UNITED STATES
NUCLEAR REGULATORY COMMISSION
WASHINGTON, D. C. 20555

January 28, 1981

The Commission has issued the enclosed Amendments Nos. 92, 92, and 89 for Licenses Nos. DPR-38, DPR-47 and DPR-55 for the Oconee Nuclear Station, Units Nos. 1, 2 and 3. These amendments consist of changes to each license and to the Station's common Technical Specifications (TSs) and are in response to your applications dated May 21, 1979; October 2, 1980, as supplemented October 30, 1980; and October 20, 1980.

These amendments: 1) revise the TSs regarding the high pressure trip setpoint and the pressurizer power operated relief valve setpoint; 2) add three license conditions and additional TSs which incorporate certain of the Three Mile Island Unit No. 2 Lessons Learned Category "A" requirements; and 3) revise the TSs to include an additional portion of Regulatory Guide 1.16 in the reporting requirements.

Figure 2.3-1A

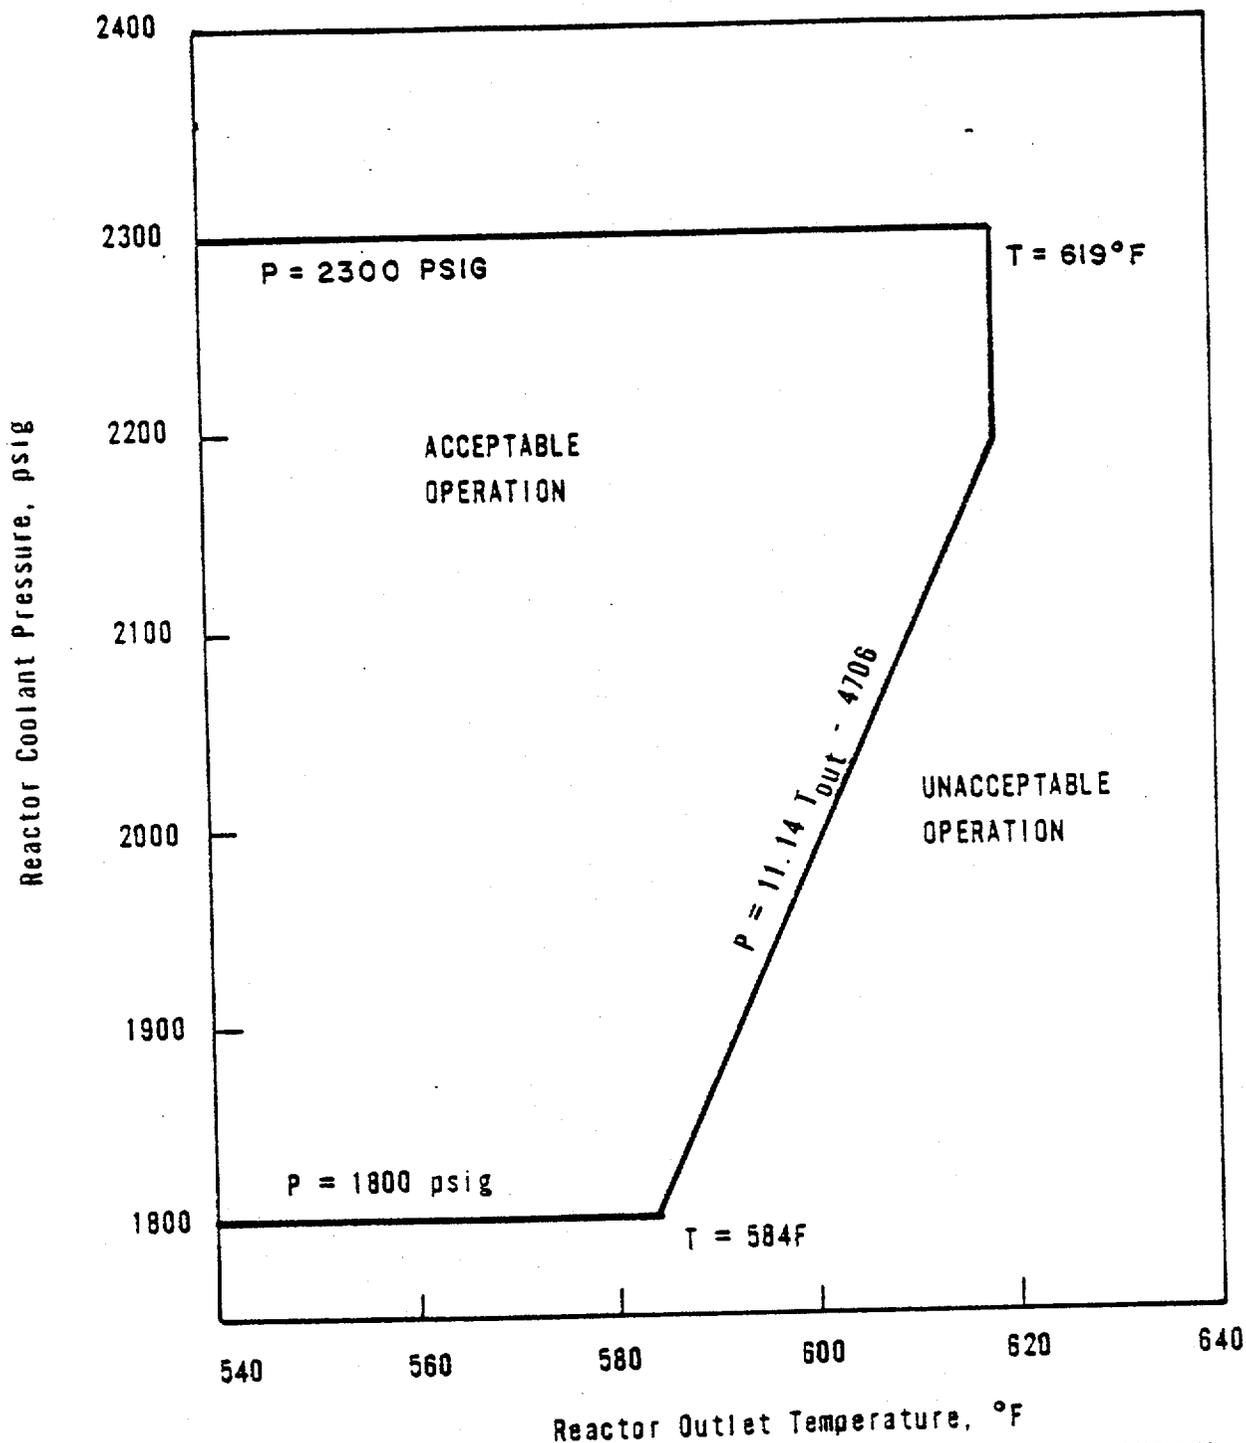
During a startup accident from low power or a slow rod withdrawal from high power, the system high pressure setpoint is reached before the nuclear over-power trip setpoint. The trip setting limit shown in Figure 2.3-1A - Unit 1

for high reactor coolant system pressure (2300 psig) has been established to maintain the system pressure below the safety limit (2750 psig) for any design transient. (1)

setpoints shown in Figure 2.3-1A have been established to maintain the DNB

The high reactor coolant outlet temperature trip setting limit (619°F) shown in Figure 2.3-1A has been established to prevent excessive core coolant

In response to IE Bulletin 79-05B, the licensee submitted by letter dated May 21, 1979, a proposed amendment to the TSs lowering the setpoint of the high pressure reactor trips from 2355 psig to 2300 psig. Concurrently, the licensee proposed raising the setpoint of the pressurizer electromechanical relief valves, also known as the power operated relief valves (PORV), from 2255 psig to 2450 psig. The licensee physically changed the setpoints prior to the TS change request, as part of his response to IE Bulletin 79-05B. The lowered high pressure trip setpoint was within the envelope of the existing TS, thus the licensee did not need this change to be issued to lower the setpoint. The PORV setpoint is not subject to TS limitations; however, the PORV setpoint is identified in the basis of TS Section 2.2 - Safety Limits-Reactor Coolant System Pressure.

In the past, during turbine trip and loss of feedwater transients, the PORV was lifted and the reactor would not trip unless the pressure setpoint was exceeded. With the new setpoints, these transients do not result in lifting of this valve. Therefore, this valve does not open as frequently and the likelihood of the valve failing to close, i.e., producing a small break loss of coolant event, is reduced. However, the likelihood of a reactor trip is increased. We do not consider this increase in frequency of a reactor trip to be significant over the lifetime of the plant. The PORV function is to control an operational transient and not to protect the reactor coolant system pressure boundary. The safety valves provide this function. The new setpoints would not reduce the margin of safety or increase the probability or consequences of accidents. We find the proposed changes to the TSs acceptable.

Figure 2.3-1B

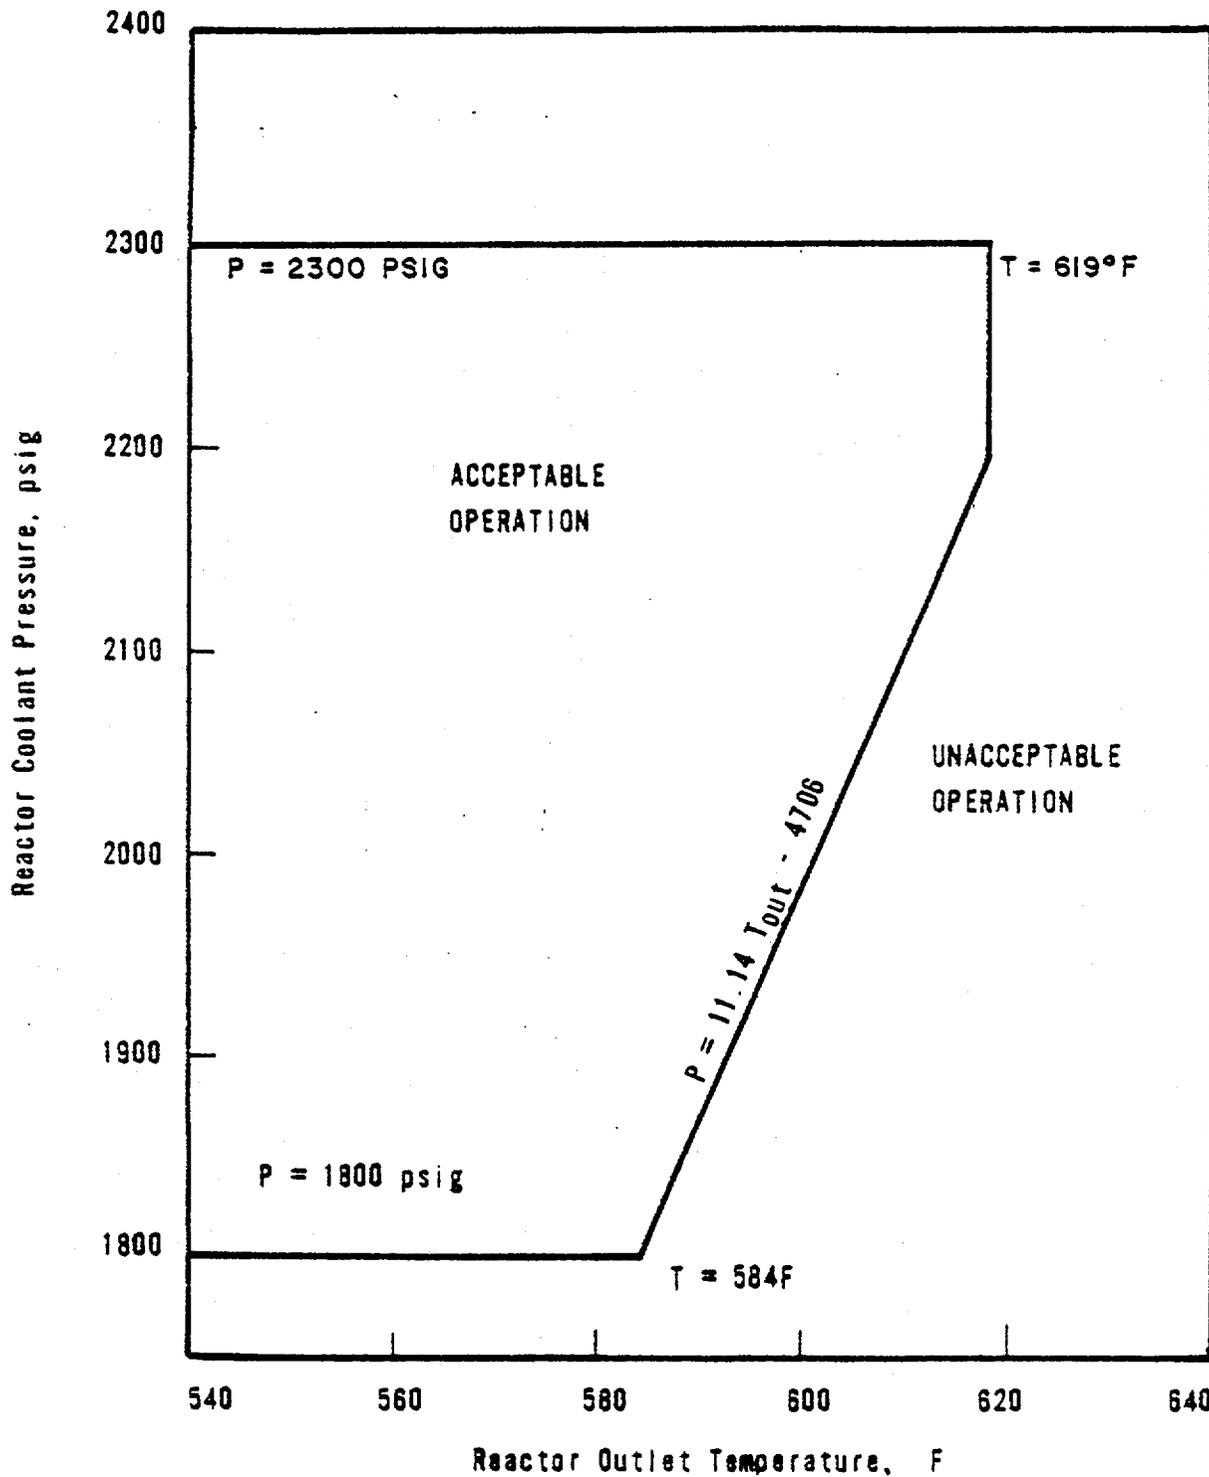
- 2.3-1B - Unit 2
- 2.3-1C - Unit 3

- 2.3-1B
- 2.3-1C

- 2.3-1B
- 2.3-1C

OCONEE NUCLEAR STATION
 STATION ORGANIZATION CHART
 FIGURE 6.1-1

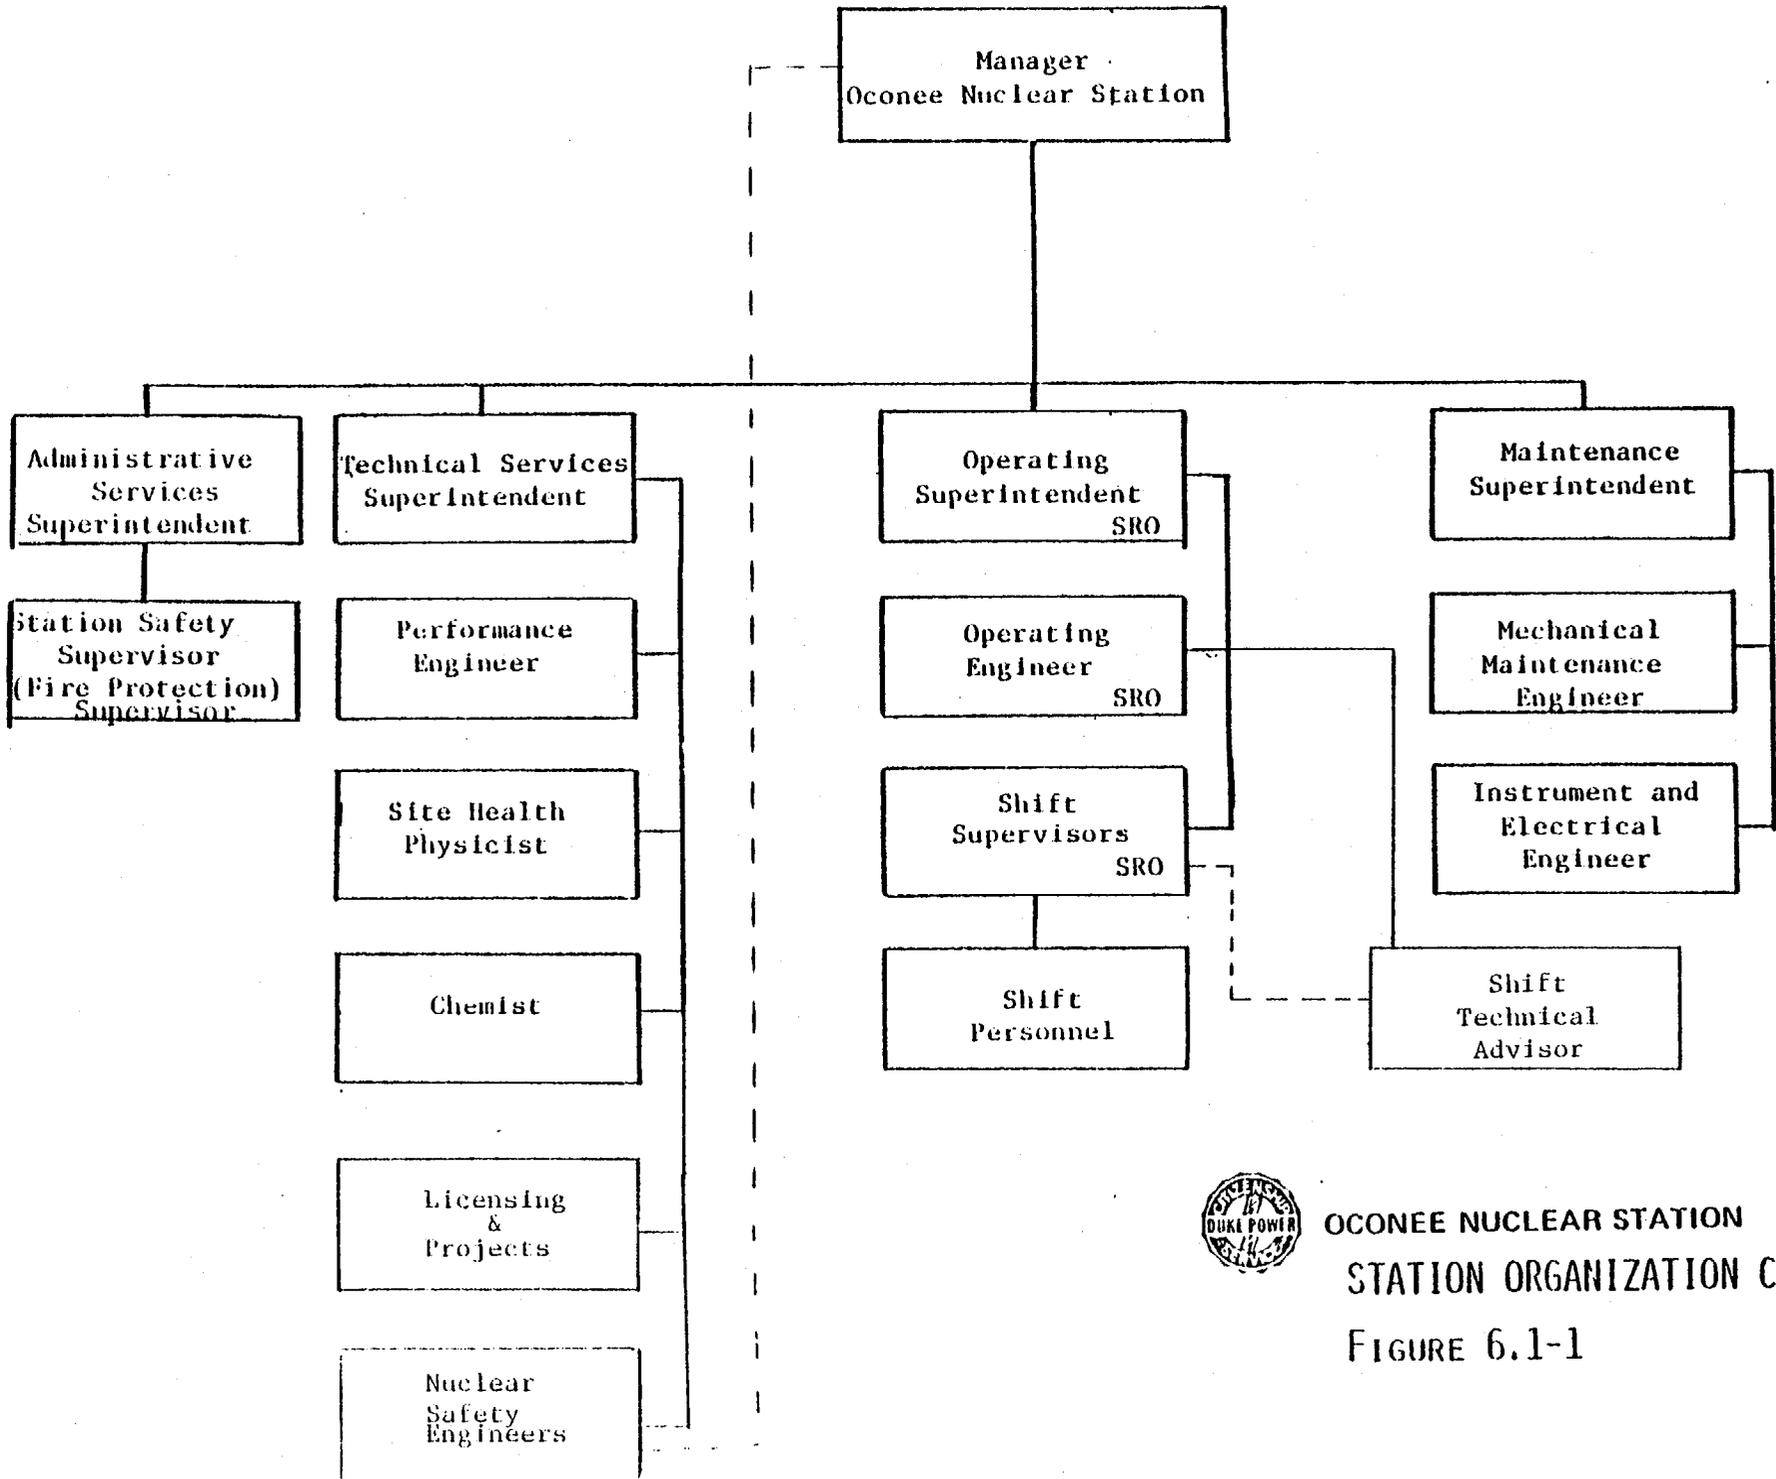
- 6.1.1.3 The station organization for Operations, Technical Services and Maintenance shall be functionally as shown in Figure 6.1-1. Minimum operating shift requirements are specified in Table 6.1-1.

Our request indicated that the TSs related to minimum shift manning should be revised to reflect the augmentation of an STA. The licensee's application would add one STA to each shift to perform the function of accident assessment. The individual performing this function will have at least a bachelor's degree or equivalent in a scientific or engineering discipline with special training in plant design, and response and analysis of the plant for transients and accidents. The operating experience review function will be performed by a group of on-site staff engineers who will keep the STA informed of the results of the operational analysis function; this is in agreement with our April 7, 1980 Safety Evaluation. Based on our review, we find the licensee's submittal to satisfy our requirements and is acceptable.
